22 November 2021

3200126

Arden Structure Plan – Submission to Victorian Planning Authority

Figure 4 - Spatial distribution of retail floorspace demand – Arden Structure Plan

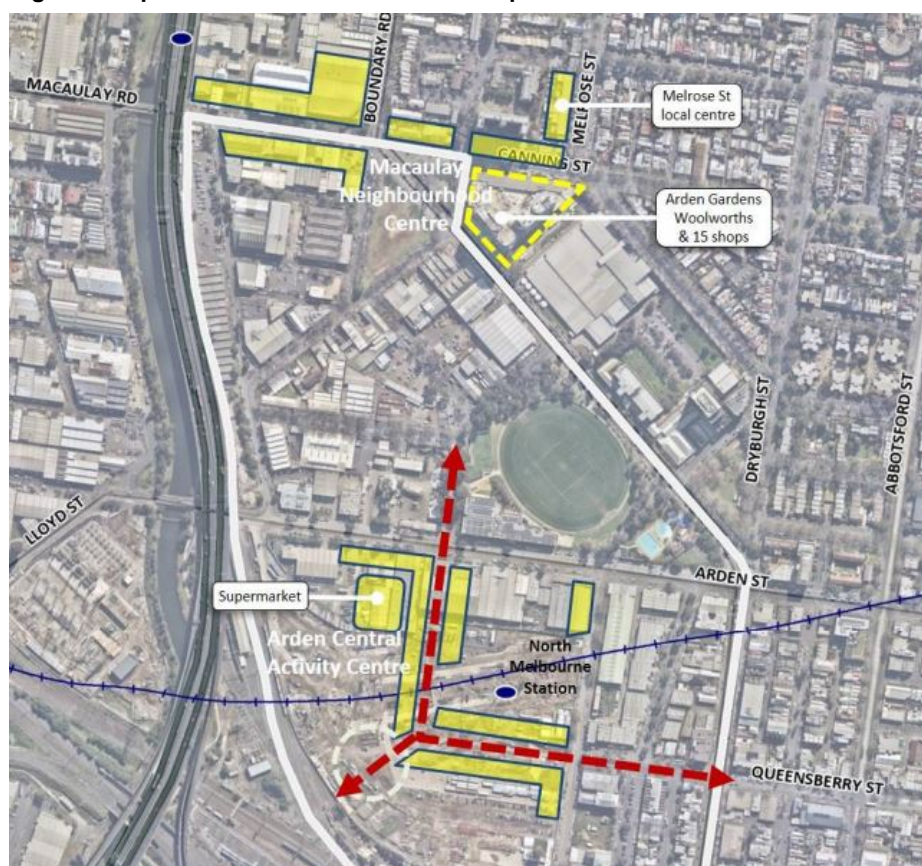
The requirement for active street frontages along all mid-block pedestrian links suggests that retail or service uses will be required to occupy a significant proportion of floor space along these interfaces. The provision of retail type uses to this extent is not supported by the retail demand assessment prepared in support of the Arden Structure Plan or by the relatively remote location of the precinct to the CBD. The *Arden Retail Demand Strategy (Deep End, 2018)* analysed retail demand in the local area and identified a total demand of 22,488m² of retail floor space for the precinct. It went on to specificity sites suitable for retail uses in the Arden precinct (**see Figure 4**).

The DDO81 requires 80% of *all* mid-block pedestrian links to be entry or display window, however this requirement is not supported by the retail demand assessment, which only identified a selection of properties in the precinct suitable for retail uses. While some level of active interface will be included in any effective design of building frontages the requirement for 80% is equal to that required in the CBD context. The fails to reflect the city fringe location of Arden and the impact slope can have on limiting floor levels and provision of active interfaces at ground floor level. The requirement for entry or display window should be reduced to enable a more appropriate built form outcome to the specific Arden context.

Figure 5 - Built Form Modelling, 189 – 197 Arden Street

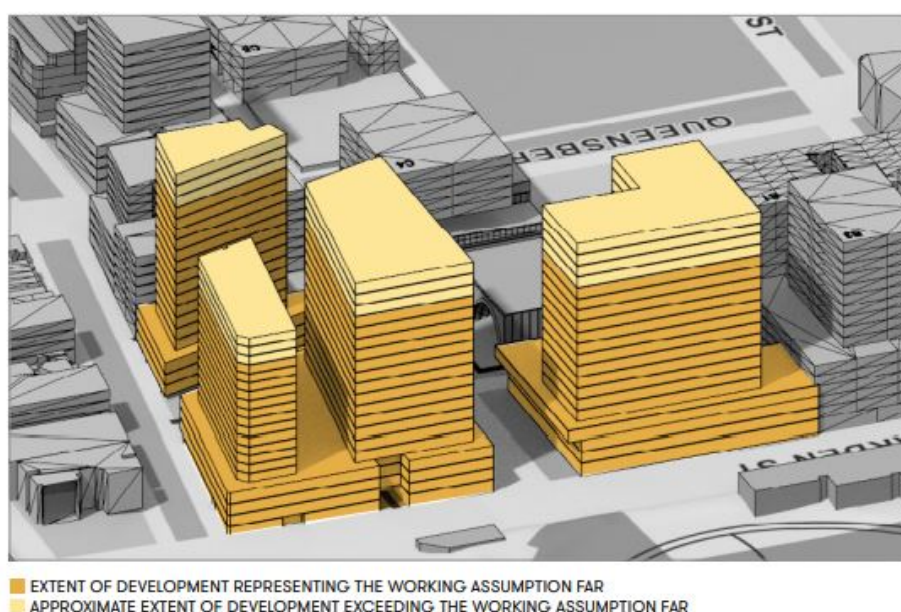
The current draft DDO enables a small cantilever over the setback area at the upper podium levels (**see Figure 5**). The floorplate able to be provided in this area does not provide commercial viability for the construction of a cantilevered element. Accordingly, there is no value to the landowner in this provision to offset the requirement for the setback.

If this space is required for public open space, it should be acquired via the application of the Public Acquisition Overlay. The PAO has been applied in other areas of the precinct for the purpose of acquiring land for footpath/road widening and should be consistently applied across the precinct, with the Department of Transport as the acquiring agency.
